Access Compliance Report

Public Rights-of-Way (Curb Ramps)

Intersection ID: 48606	Main Street: PIEDMONT_ROW_DR	Cross Street: CARNEGIE_BV	Location: SW
ADA ID: 0F15E466D623	Ramp Type: Directional1	Initial Pass/Fail: Fail	Overall Compliance: No
		Severity Score: 1.25

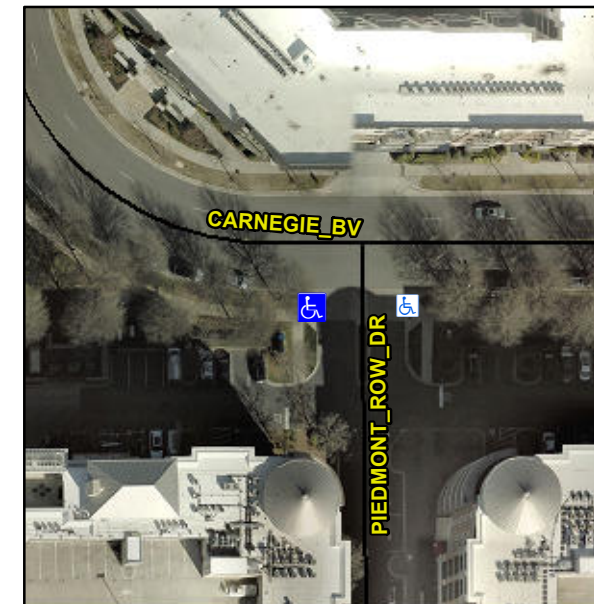
R304.5.3

Compliance	Description	Data	Compliance	Description	Data
N/A	Ramp Length (in)	26.0	N/A	Grade Break?	N/A
Yes	Ramp Width (in)	48.0	N/A	Grade Break Slope (%)	0.0
Yes	Ramp Slope (%)	4.6	N/A	Grade Break XSlope (%)	0.0
No	Ramp XSlope (%)	3.5			
N/A	Flare Type LT	N/A	N/A	Flare Type RT	N/A
N/A	Flare Slope LT (%)	N/A	N/A	Flare Slope RT (%)	0.0
N/A	Flare Traversable LT?	N/A	N/A	Flare Traversable RT?	N/A
N/A	Landing Length (in)	0.0	N/A	DWS Provided?	N/A
N/A	Landing Width (in)	0.0	N/A	DWS Contrast?	N/A
N/A	Landing Slope (%)	0.0	N/A	DWS Length (in)	N/A
N/A	Landing X Slope (%)	0.0	N/A	DWS Full Width?	N/A
N/A	Landing Curb? (Y/N)	N/A	N/A	DWS Offset LT (in)	N/A
N/A	Shared Landing?	N/A	N/A	DWS Offset RT (in)	N/A
N/A	Gutter Ponding?	0.0	N/A	Gutter Slope (%)	N/A
N/A	Gutter Lip Ht (in)	0.0	N/A	Gutter X Slope (%)	N/A
N/A	Painted X Walk1?	No		Road Slope (%)	1.9
	X Walk 1 Direction	To E		Road X Slope (%)	2.1
	X Walk 1 Width (in)	N/A		Clear Space?	N/A

Remove & Replace Entire Ramp.
